| Well Name: BEN COM | Well Location: T23N / R10W / SEC 18 / SESE / 36.222697 / -107.933246 | County or Parish/State: SAN JUAN / NM |

Notice of Intent

| Type of Submission: Notice of Intent | Type of Action: Plug and Abandonment |

Notice of Intent – Plug and Abandonment

Planned P & A Wellbore Schematic

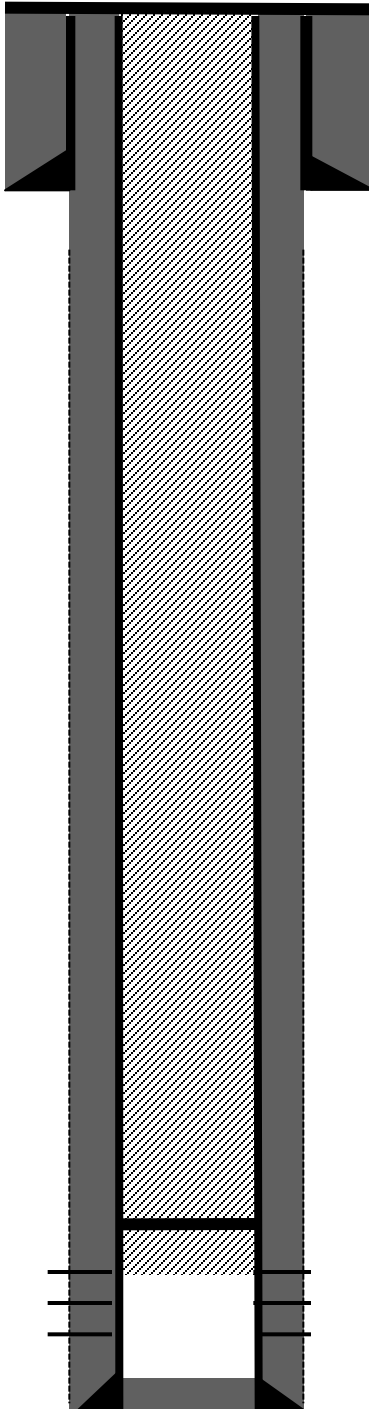
1. Plugging operations authorized are subject to the attached "General Requirements for Permanent Abandonment of Wells on Federal and Indian Lease."
2. The following modifications to your plugging program are to be made:
 - a. Complete wellbore fill up. No changes to the procedure.
3. **Notification:** Farmington Office is to be notified at least 24 hours before the plugging operations commence at (505) 564 7750.

Complete wellbore fill up. No changes to the procedure.
